ST MARYS FREIGHT HUB

RESPONSE TO SUBMISSIONS

PREPARED FOR:
PACIFIC NATIONAL

OCTOBER 2019

FIGURE 30 UPDATED – IMPACTS REQUIRING OFFSET

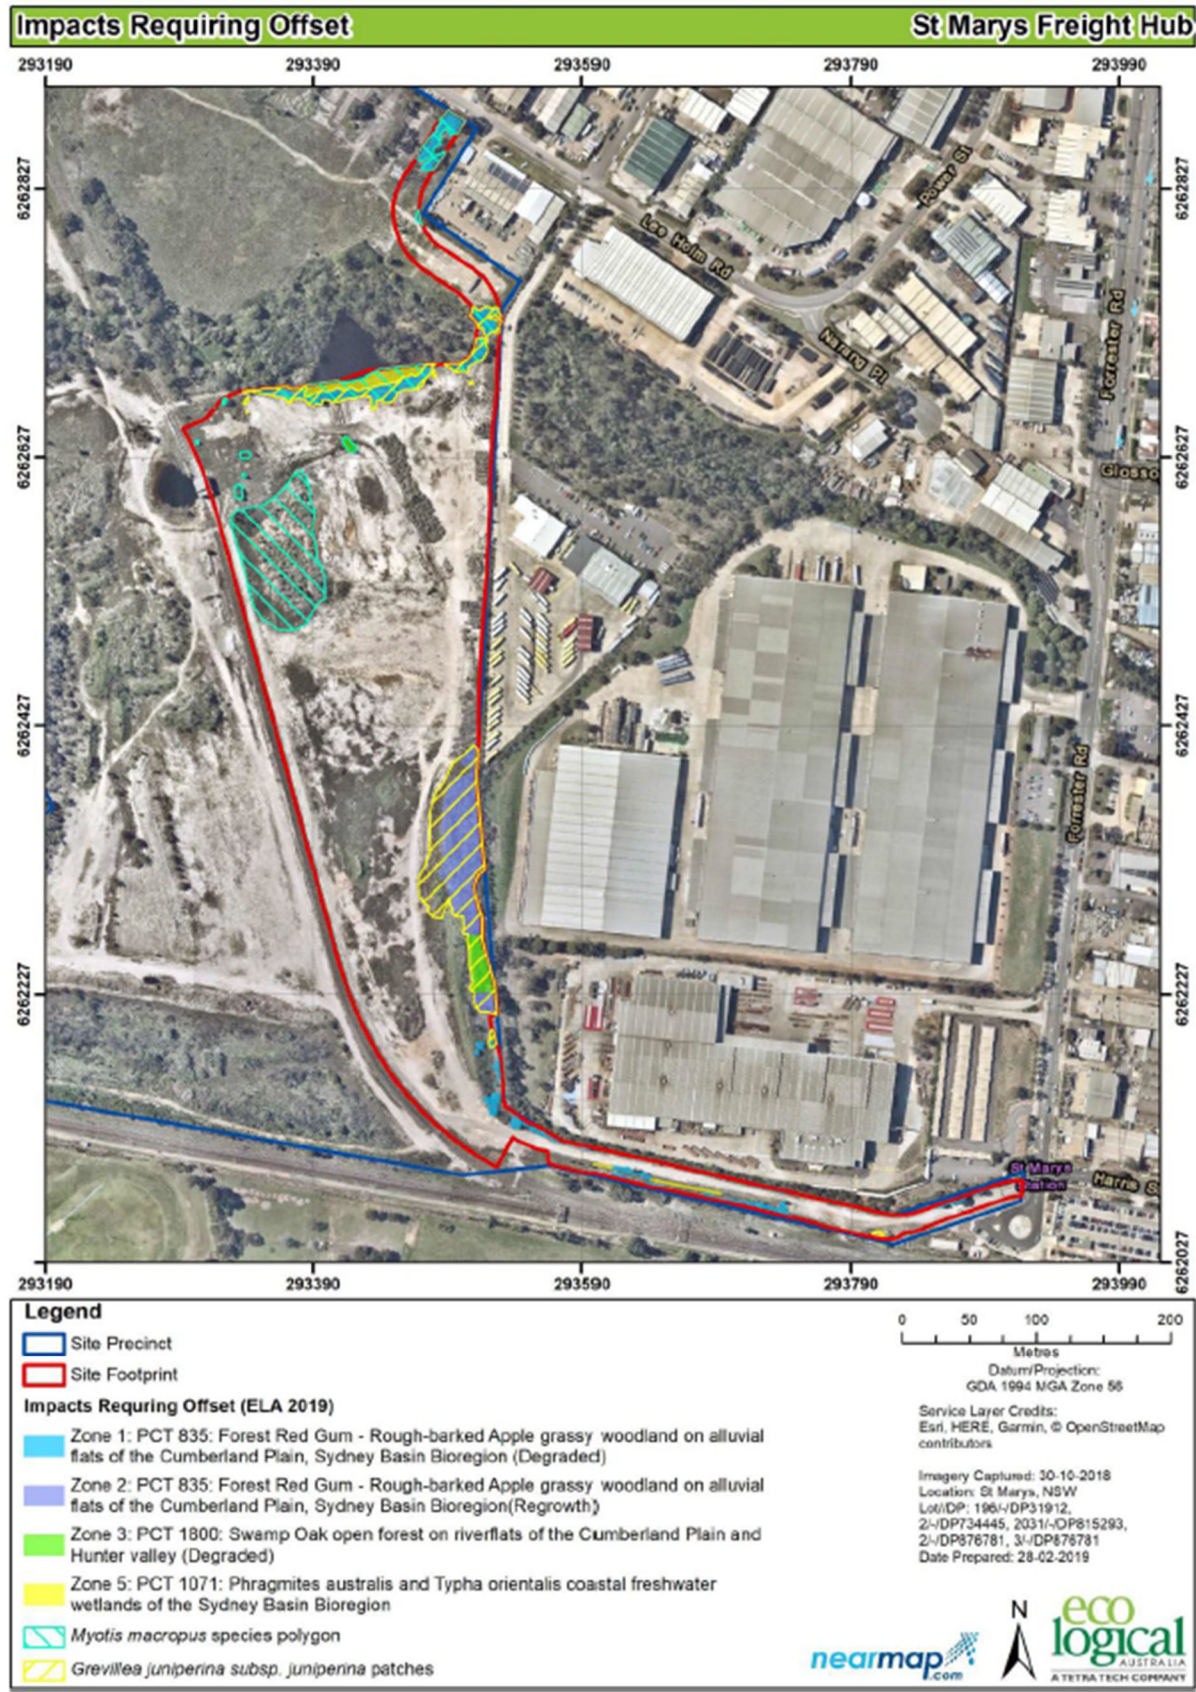
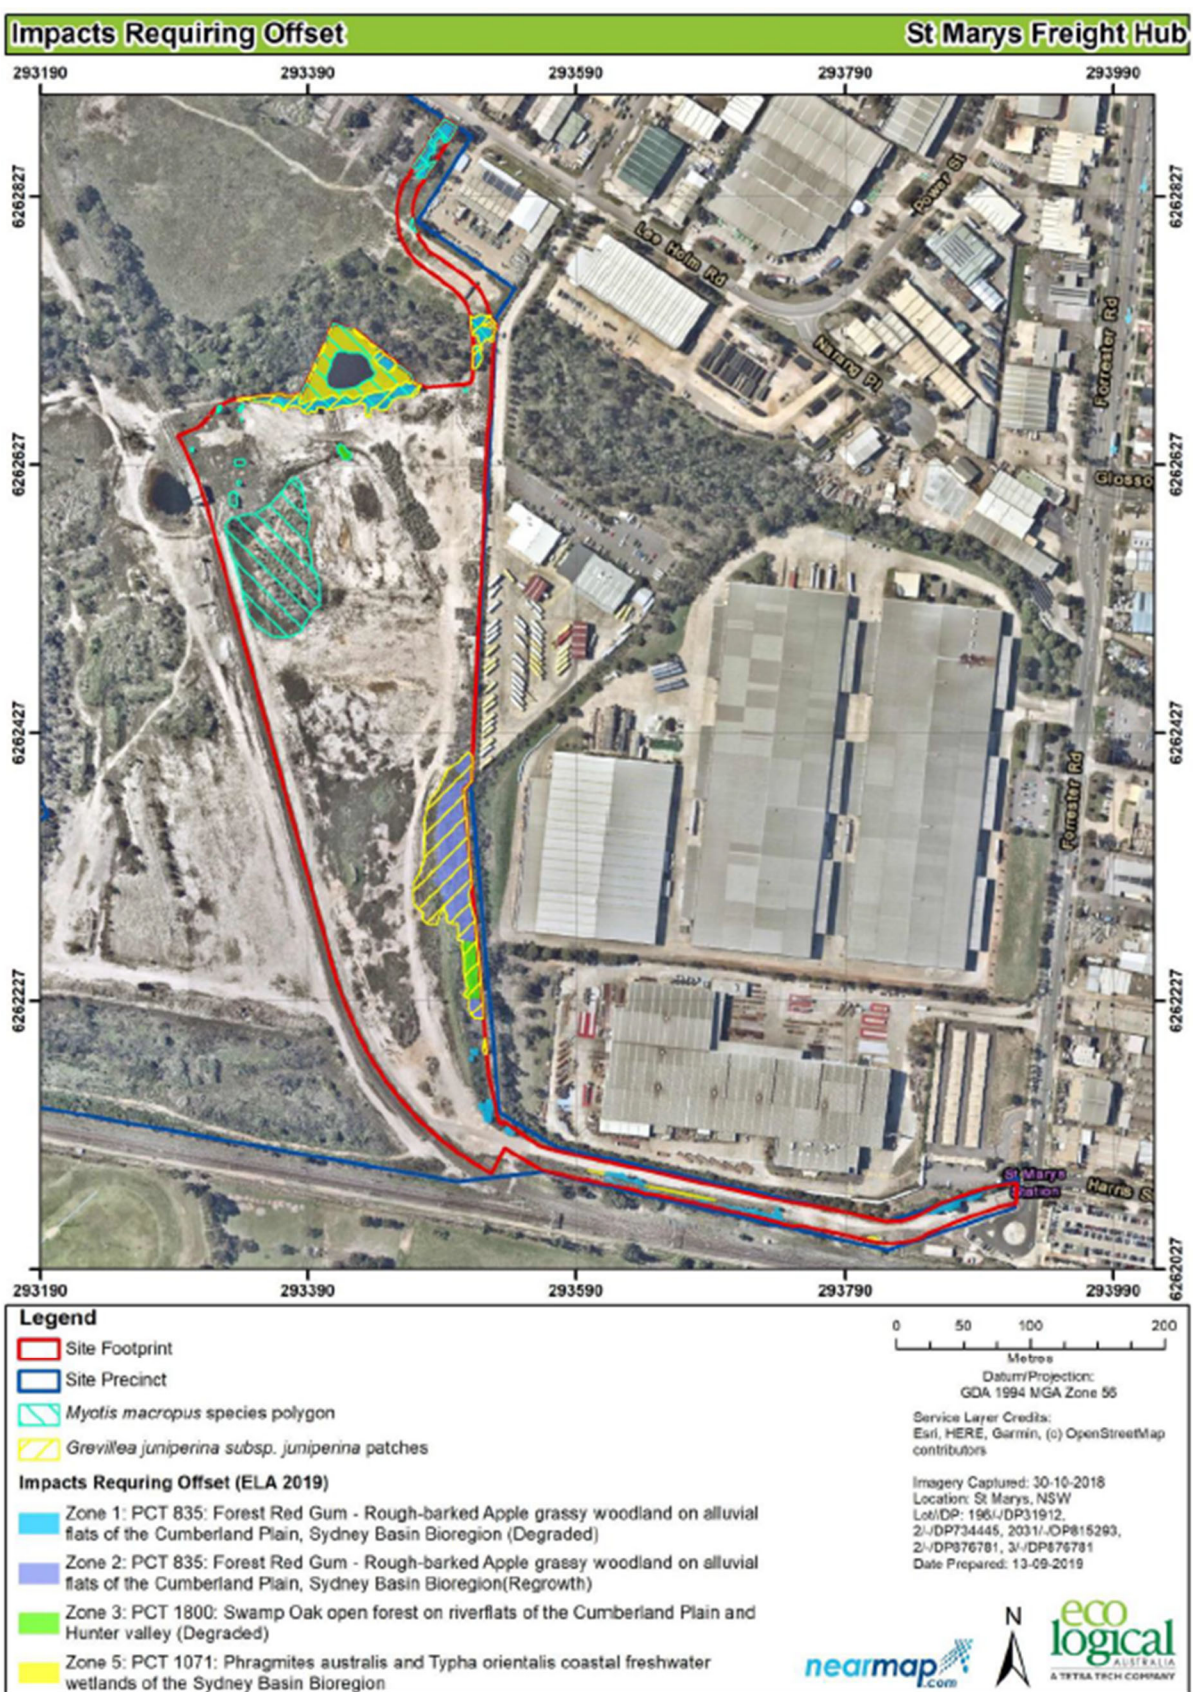
Figures 29 and 30 below, illustrate the exhibited and updated report figures illustrating the impacts that require offsets. Refer to Appendix 13 – Biodiversity Development Assessment Report.

FIGURE 31 TRUCK ROUTE - OPTION 1

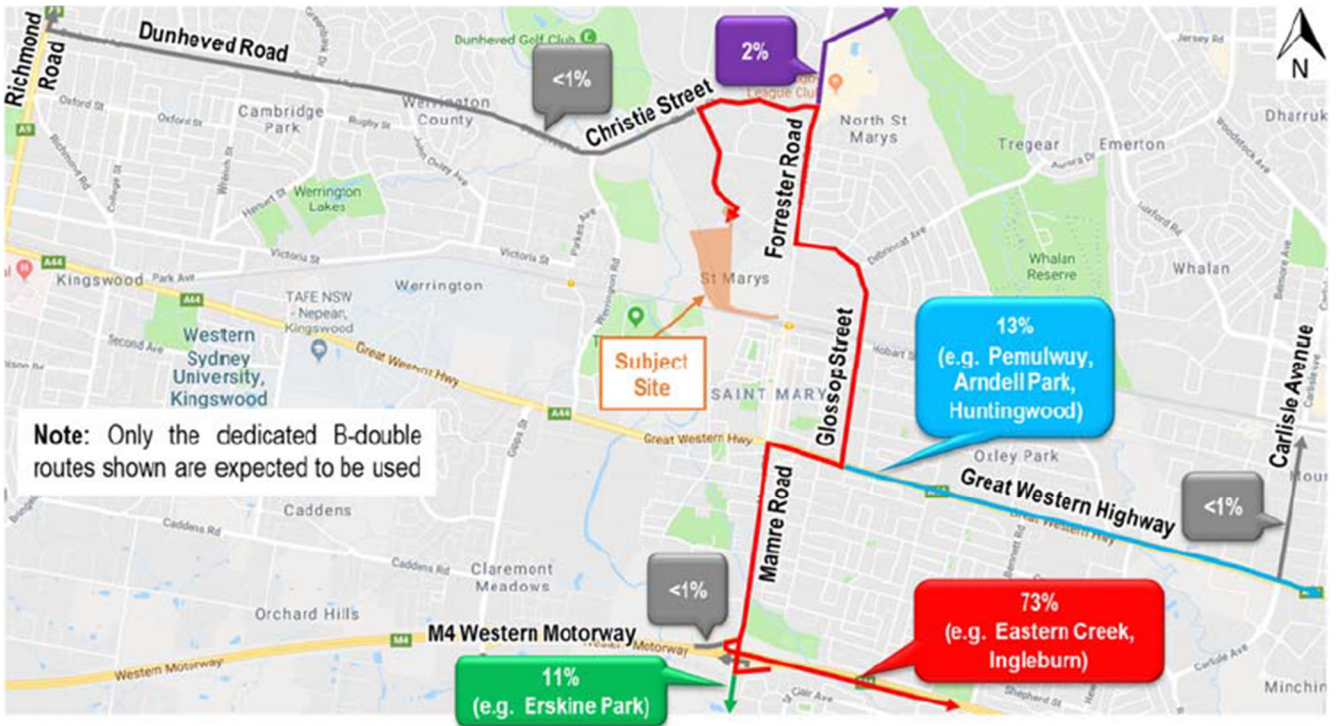
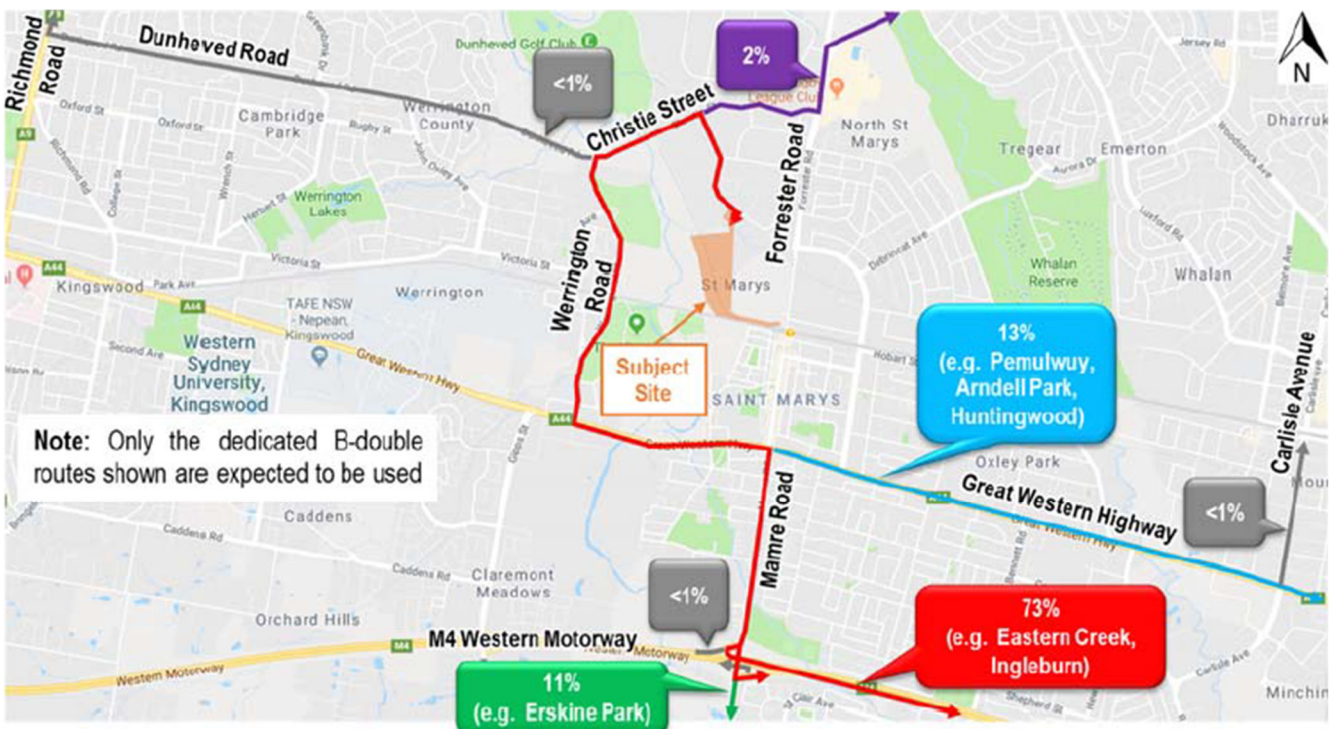
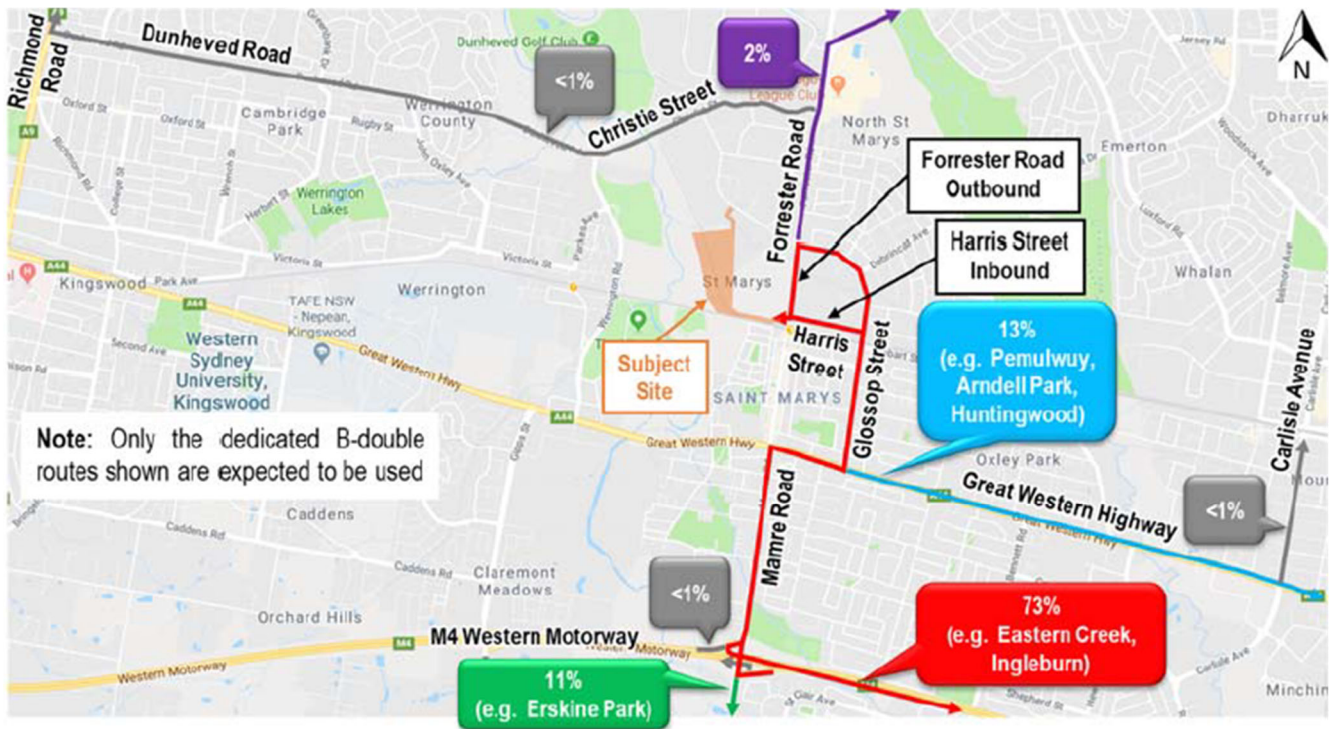
The four options (Refer to **Figures 31 to 34** below) considered were:

- Option 1 – EIS exhibited option – trucks utilising Lee Holm Road primarily via Christie Street, Forrester Road and Glossop Street
- Option 2 – Trucks entering and exiting via Lee Holm Road primarily via Christie Street and Werrington Road
- Option 3 – Trucks entering and exiting the site at Forrester Road (using Harris Street westbound as entry route and Forrester Road – Glossop Street for the egress route)
- Option 4 – Trucks entering and exiting the site at Forrester Road with Glossop Street / Forrester Road as the nearest intersection accommodating inbound and outbound movements.
